AN BORD PLEANÁLA

facade consultants

Ground Settlement.

ML1-JAI- EIA-ROUT-XX-DR-Y-21146 rev P02

EWS-001 Window Wall. South Elevation. Worst Case.

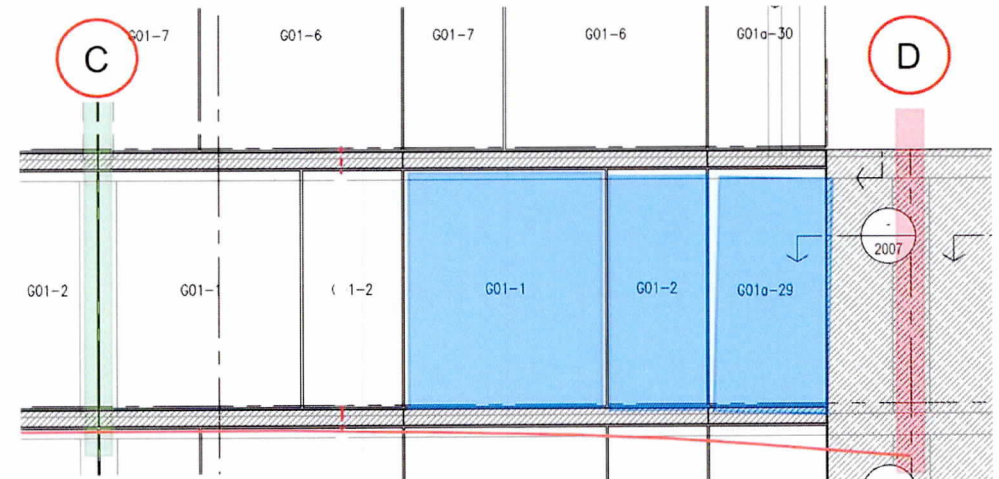
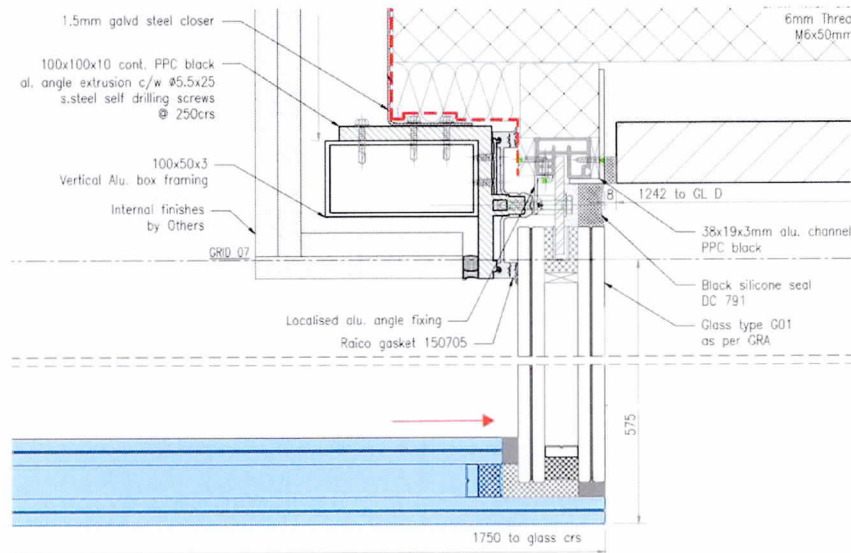
Due to the aspect ratio of the panels closest to gridline D on the South elevation, the TII predicted differential settlement of **25mm from Gridline C to D** would result in **1.75m** wide panels rotating in plane not less than **3.6mm** at their base. As each panel is **3.5m tall this translates into 7mm rotation** at the top corner of the panel. Such rotation would exceed the design parameters of the structural sealant at the glass to glass joint crushing and tearing the sealant and inducing stress in the glass. It may not cause breakage but will apply long-term stress into the structural sealant joint which may cause failure of the structural connection.

EWS-002 Suspended Stone Veil. South Elevation. Worst Case.

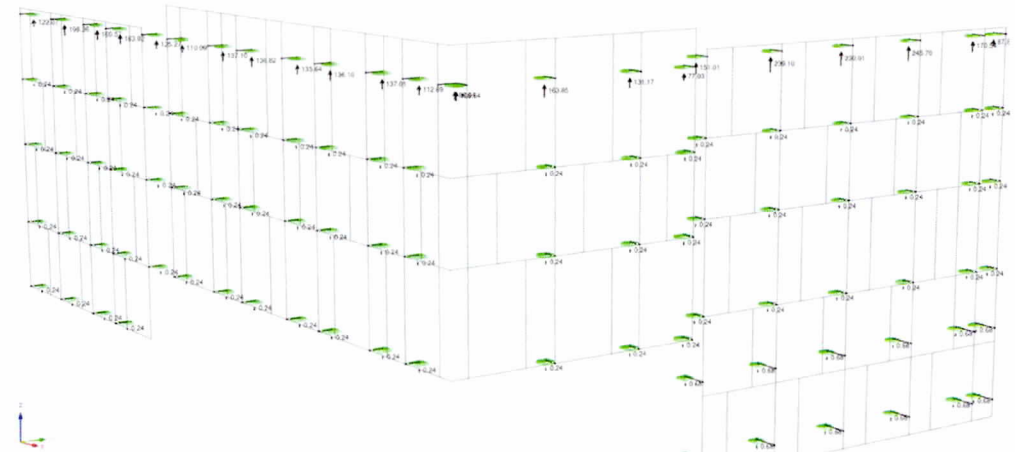
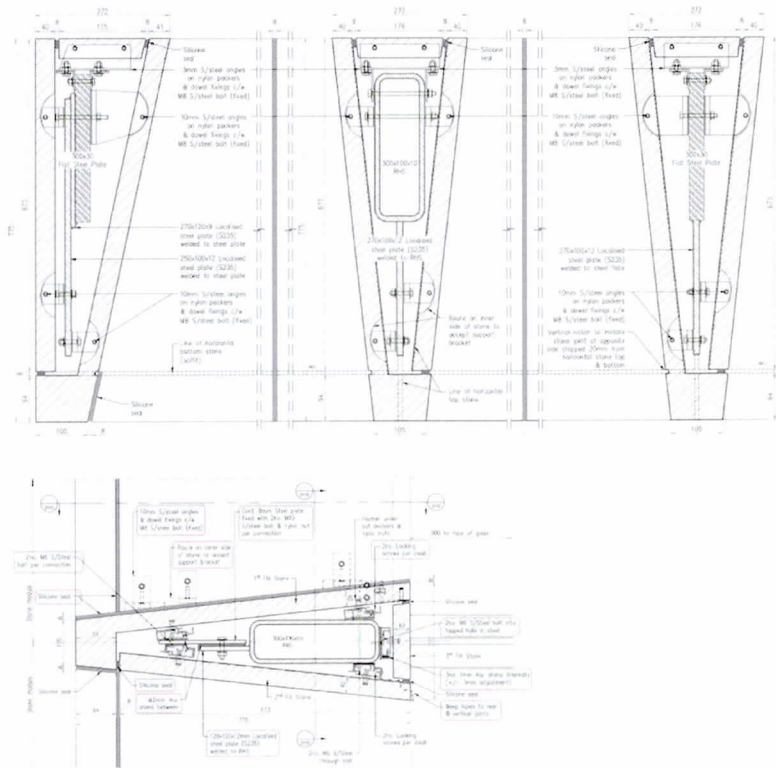
The stone veil is supported from the terrace slab at fifth floor level. The veil consists of individual pieces of hand-set limestone with undercut anchors and aluminium support rails fixed back to a bespoke stainless steel and galvanised steel suspension structure. Differential movement (racking) of the primary structural floors causes the veil suspension structure to deform out of square.

EWS-002 Suspended Stone Veil. South Elevation. Worst Case.

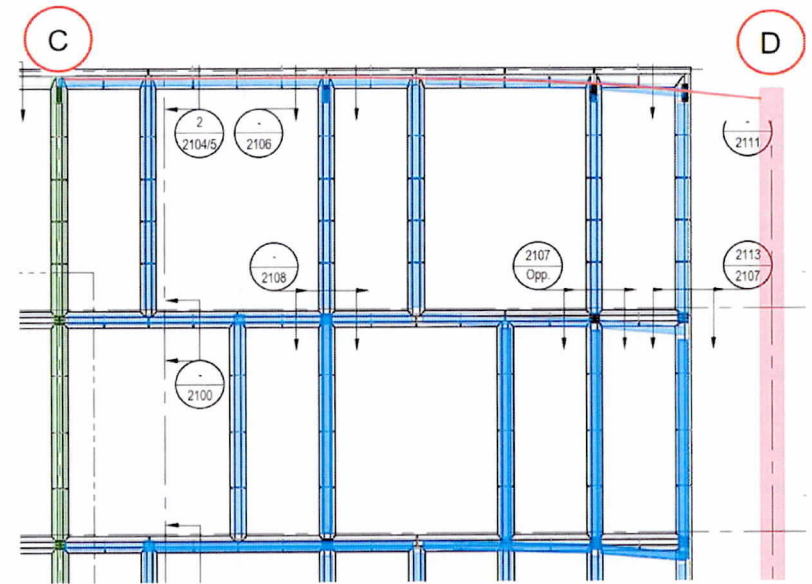
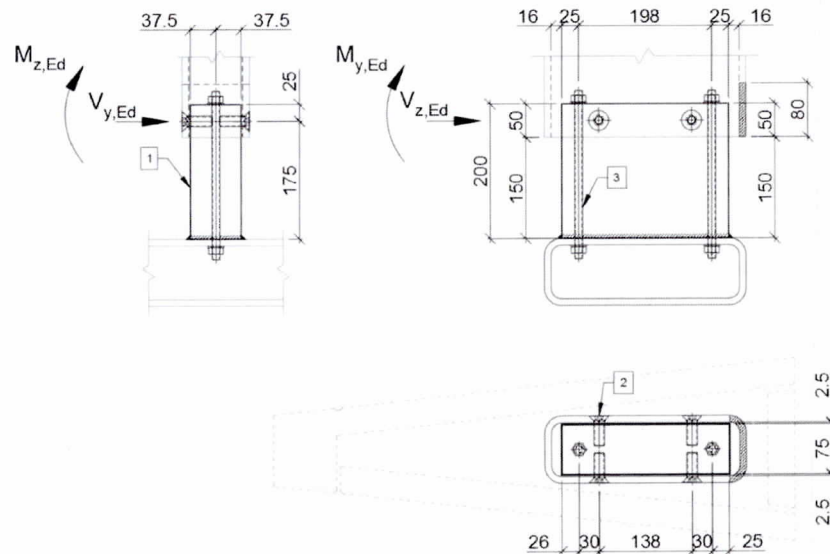
The differential settlement of a column **25mm from Gridline C to D** causes rotation of the connection between horizontal and vertical veil elements. These connections are typically formed with countersunk fixings tapped into a block of stainless steel. These connections were not designed to accommodate significant rotation. Detailed analysis would be required to determine how these connections react and whether the horizontal beams of the veil would rotate at these connections or be forced to go into bending (**'S' shaped bend on elevation**). If over-stressed the connections could fail.

If the horizontal beams or vertical mullions go into bending due to differential settlement, this could cause **over-stressing of the fixings in the stone exceeding permissible safety factors and/or causing cracking of the stone.**

EWS-003 Stick System Curtain Wall. Worst Case Recessed South Elevation

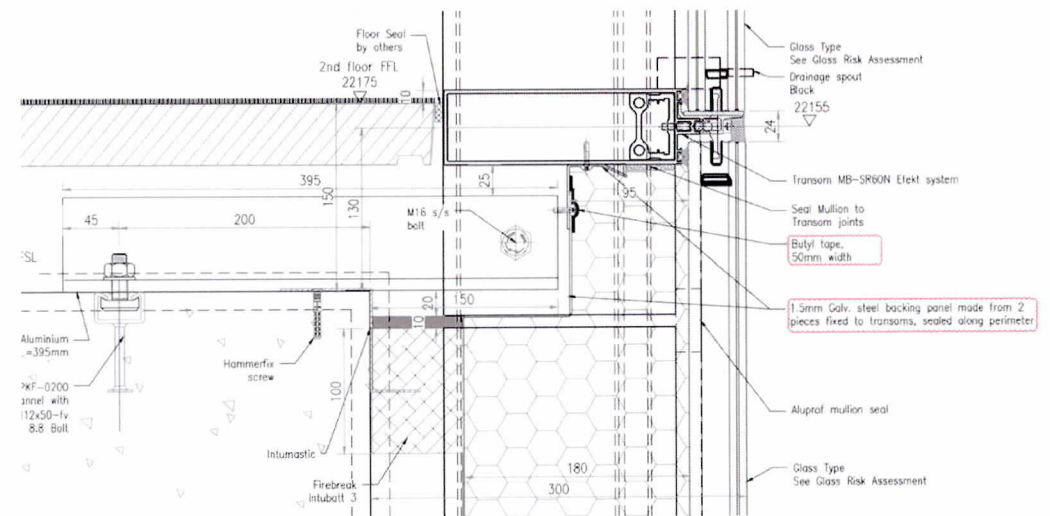
When the structure moves differentially, the mullions remain vertical and the transoms rotate in plane. As each glass unit sits on a transom, the glass rotates with the transom. Based on the TII diagram there is approximately **30mm of differential settlement across quite a small width of approximately 10m.** Due to the aspect ratio of the panels closest to gridline D1 on the South elevation, the TII predicted differential settlement of **30mm in this area** would result in **1.5m wide panels** rotating in plane not less than **4.5mm at their base**. As each panel is **3.8m tall** this translates into **11mm rotation** at the top corner of the panel. The toggle glazed system does not have capacity for this degree of movement.

EWS-006 Entrance Glazing.

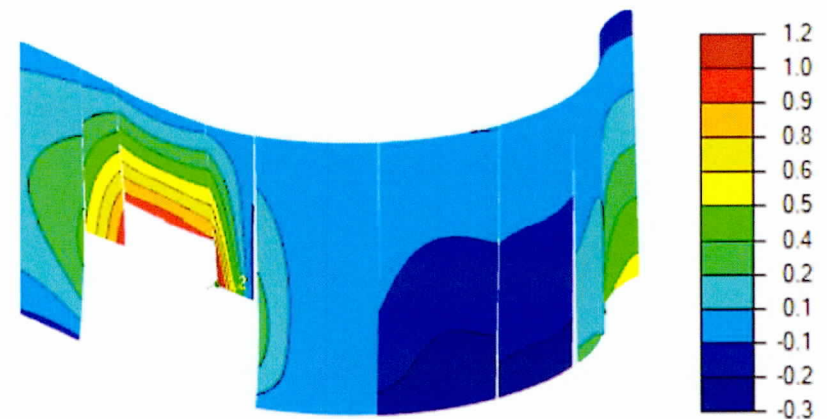
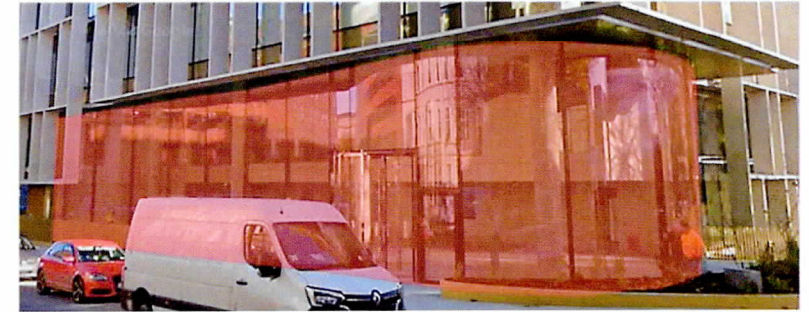
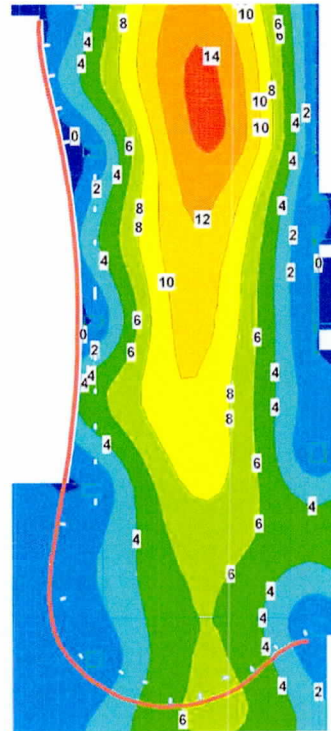
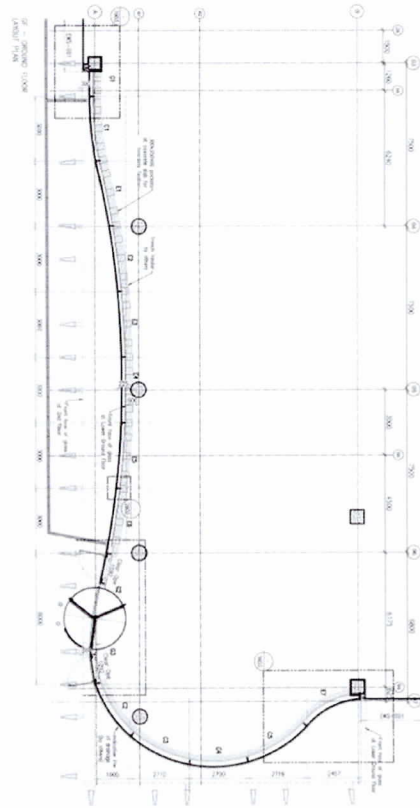
The entrance glazing is a bespoke glazing system formed from curved double-glazed units up to 6.7m tall restrained by stainless steel flat plates at glass to glass joints. Due to their size and shape, the double glazed units are formed from laminated annealed glass rather than heat treated or toughened glass. This makes the glass particularly susceptible to breakage due to localised stresses. **Maximum vertical deflections in 'mm' of the installed screen are shown on the right in the image above.**

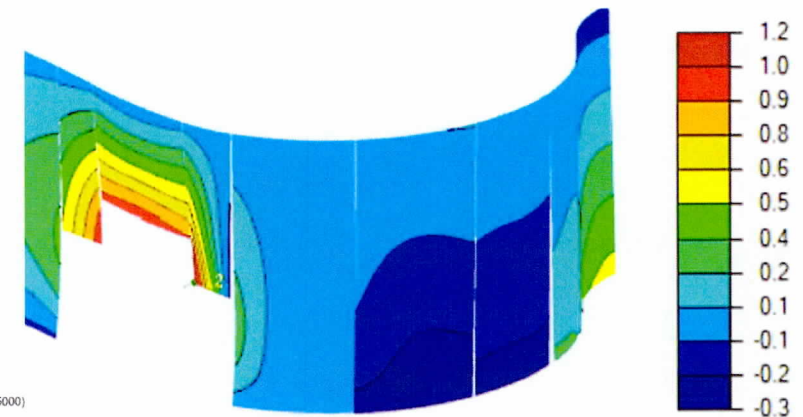
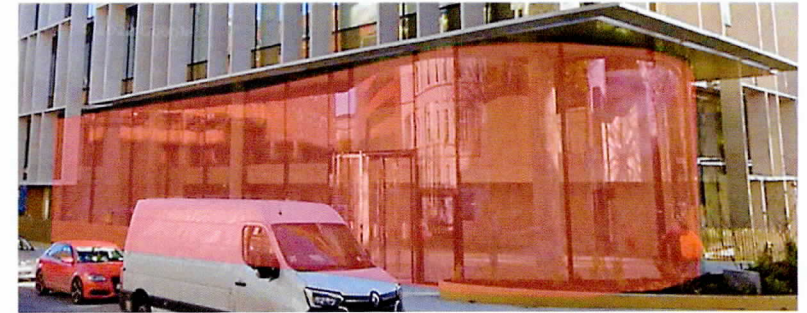
The entrance glazing is a bespoke glazing system formed from curved double-glazed units up to 6.7m tall restrained by stainless steel flat plates at glass to glass joints. Due to their size and shape, the double glazed units are formed from laminated annealed glass rather than heat treated or toughened glass. This makes the glass particularly susceptible to breakage due to localised stresses. **Maximum vertical deflections in 'mm' of the installed screen are shown on the right in the image above.**

EWS-006 Entrance Glazing.

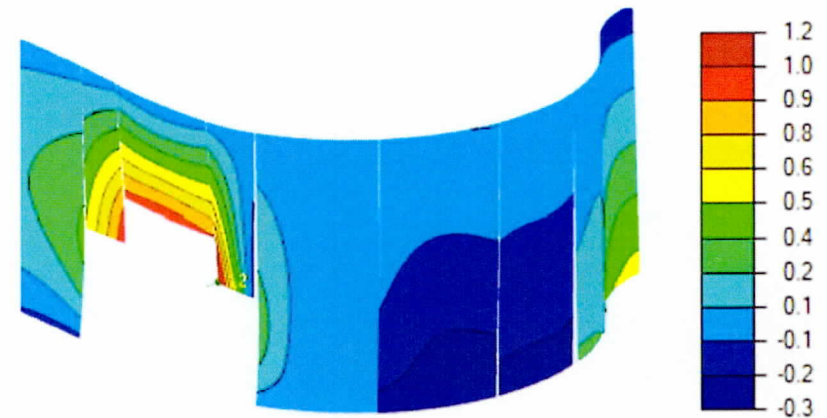
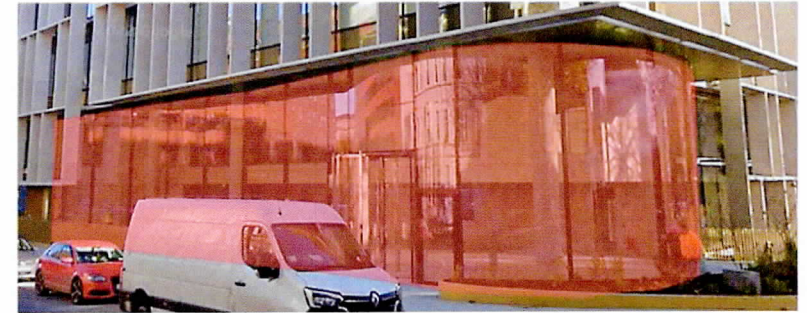
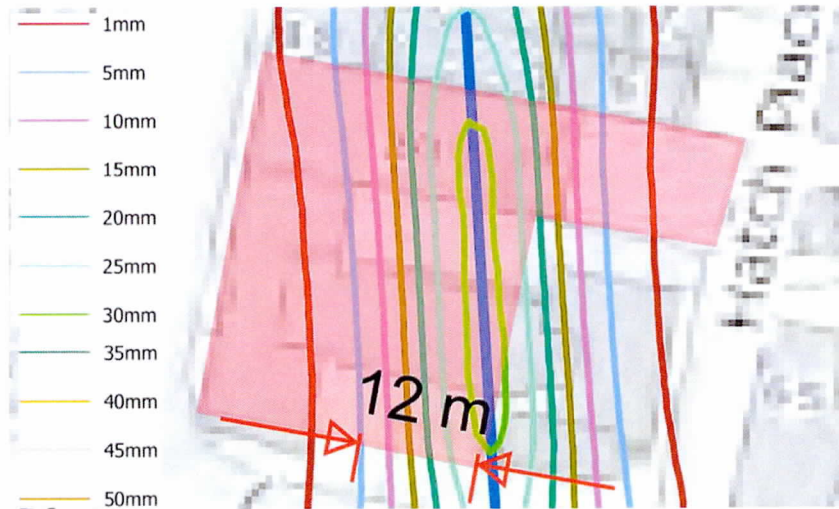
The entrance glazing is a bespoke glazing system formed from curved double-glazed units up to 6.7m tall restrained by stainless steel flat plates at glass to glass joints. Due to their size and shape, the double glazed units are formed from laminated annealed glass rather than heat treated or toughened glass. This makes the glass particularly susceptible to breakage due to localised stresses. **Maximum vertical deflections in 'mm' of the installed screen are shown on the right in the image above.**

If the tunnel is out of position to the West by 10m or 15m which we understand is within the TII's tolerances, you can see the curved glass screen will be in danger of experiencing **major differential settlement across the south** end of the screen which would cause breakage.
